## ***Interactive comment on “Intercomparison of in situ water vapor balloon-borne measurements from Pico-SDLA H<sub>2</sub>O and FLASH-B in the tropical UTLS” by M. Ghysels et al.***

Received and published: 10 February 2016

The authors wish to thank the anonymous referee 2 for his helpful comments. Below are our responses to the reviewer 2.

Fig. 4.

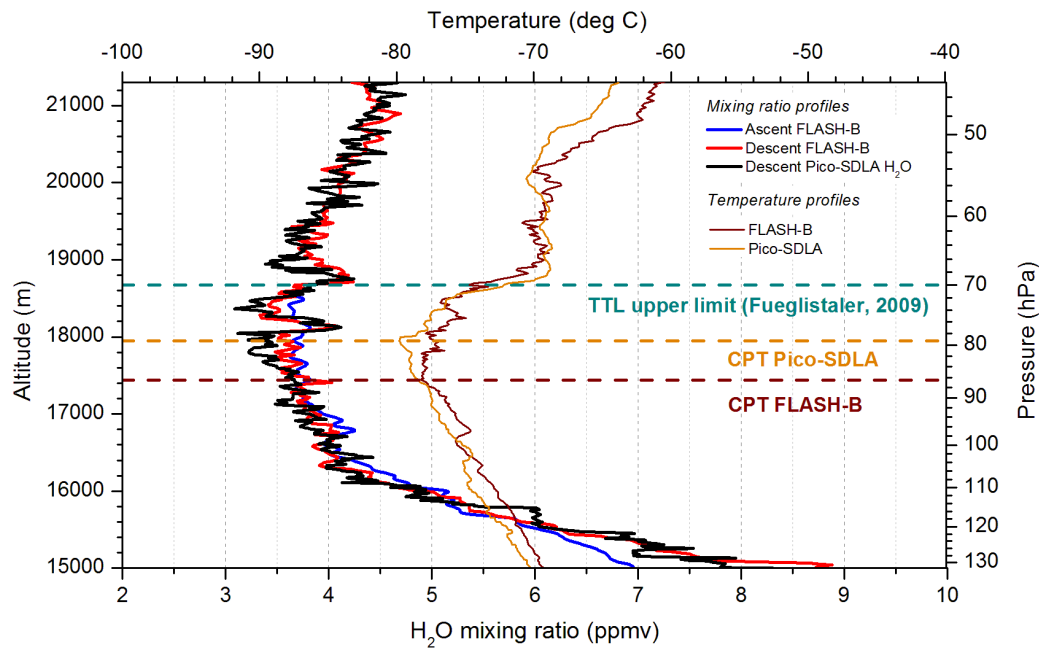
Figure 4/6: The temperature variability can be surprising. Then, the two sensors have flown 3 hrs apart following slightly different trajectories: it is conceivable that small temporal temperature changes had occurred. Then, the temperature and altitude measurements error have most probably played a role. Since these two flights occurred during nighttime, we agree that a solar heating is probably not the source of these differences.

Fig. 6.

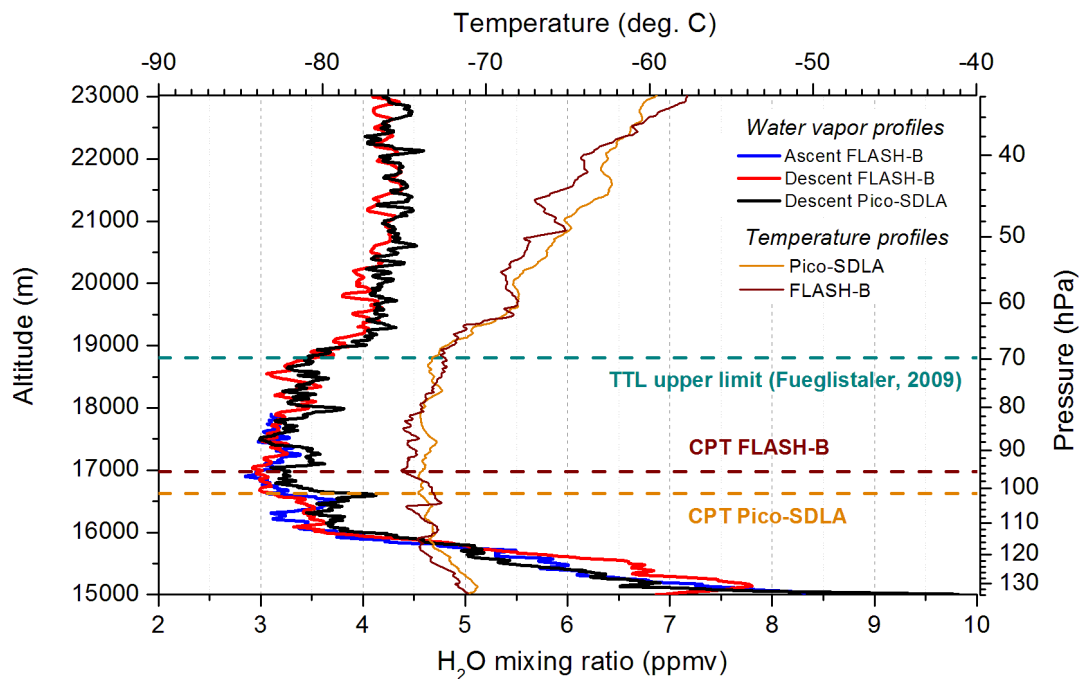
P 13708, l 14: Thank you, we omitted to remove the part above 23 km. The figure has been updated and is now Fig. 6 (instead of Fig. 4 previously).

Fig. 7.

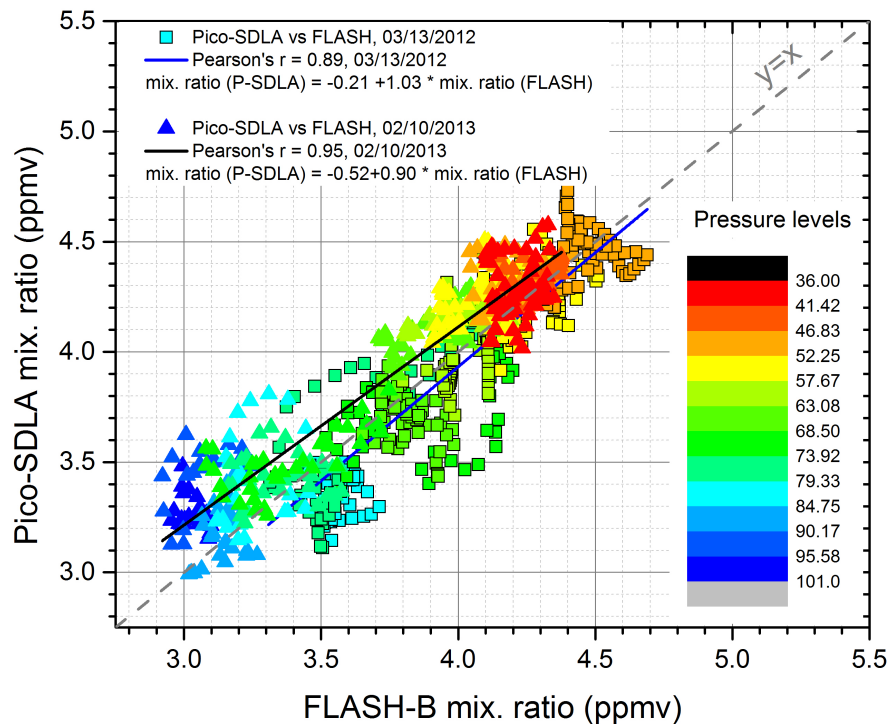
P 13712, I 11: To the best of our knowledge, the slope of the fitting equation does not represent the correlation coefficient which comes from the  $R^2$ : the Pearson's  $r$  coefficient for each flight has been discussed previously. To us, this coefficient was the most important. The instrumental bias ( $b$ ) is the mean of the difference between both sensor measurements expressed as:

This value changes from one flight to another so we concluded that there was no systematic bias. On February 10-11, 2013, the bias has been calculated to +0.12 ppmv and on March 13, 2012, it has been estimated to be -0.06 ppmv. To the best of our knowledge, this information was not accessible using the fitting equations, it is the reason why we did not include the equations initially. Since the reviewer suggested that the reader could be interested in the equations, we nevertheless added the fit equations in Fig. 7. Therefore, in the text, we added few sentences:

"A linear fit of the Pico-SDLA versus FLASH data is shown as a solid line and the equations of the fits are given. The bias ( $b$ ) has been calculated using the following

$$b = \sum_{i=1}^n \frac{\text{mix.ratio}(P - \text{SDLA})_i - \text{mix.ratio}(\text{FLASH})_i}{n} \quad (2)$$

Here  $n$  represents the number of measurements. For these two flights, between the CPT to the maximum altitude usable, the maximum bias visible is of 0.12 ppmv (February 10-11, 2013 flight). For the March 13, 2012 flight, this bias is of -0.06 ppmv. Both bias are of the same amplitude of those in (Weinstock et al, 2009), obtained from coincident flights. Since the bias varies from one flight to the other, no systematic bias has been demonstrated between Pico-SDLA and FLASH.”
